Draft White Paper

**SC&A REVIEW OF LAWRENCE BERKELEY NATIONAL
LABORATORY SITE PROFILE MATRIX ISSUES #6, #7, AND #8**

September 2012

Exhibit A: Plot of Neutron Dose vs. Photon Dose
(From ORAUT 2010b, Figure 6-2, page 59)

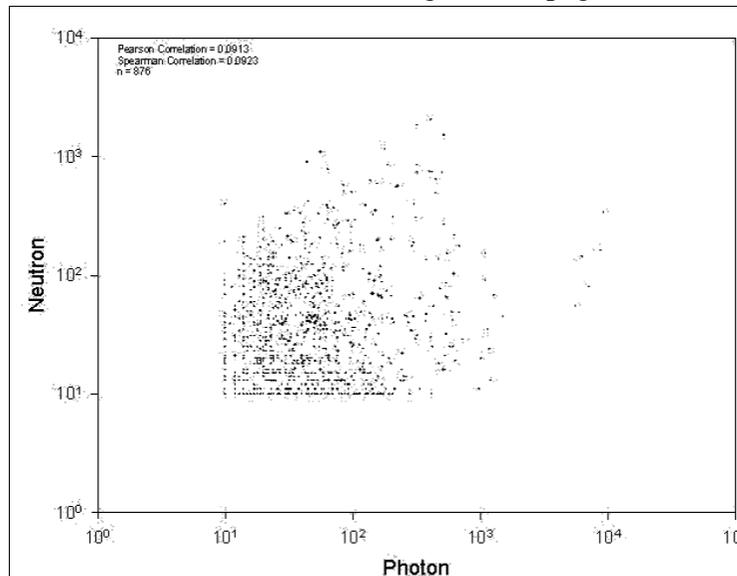
Revised TKBS-0049 - Neutron and Photon Doses are **Not** Correlated

It is stated on page 57 of TKBS-0049 (ORAUT 2010b) that, “Figure 6-2 illustrates a scatter plot of the measured neutron and photon dose. It is evident that the measured neutron and photon doses are well correlated with a Pearson Correlation of 0.09.” However, an examination of Figure 6-2 (reproduced below as Exhibit A) shows that there appears to be very little correlation between neutron and photon doses in this plot. A **Pearson Correlation of 0.0913** and a **Spearman Correlation of 0.0923** indicates a **poor** correlation between the variables.
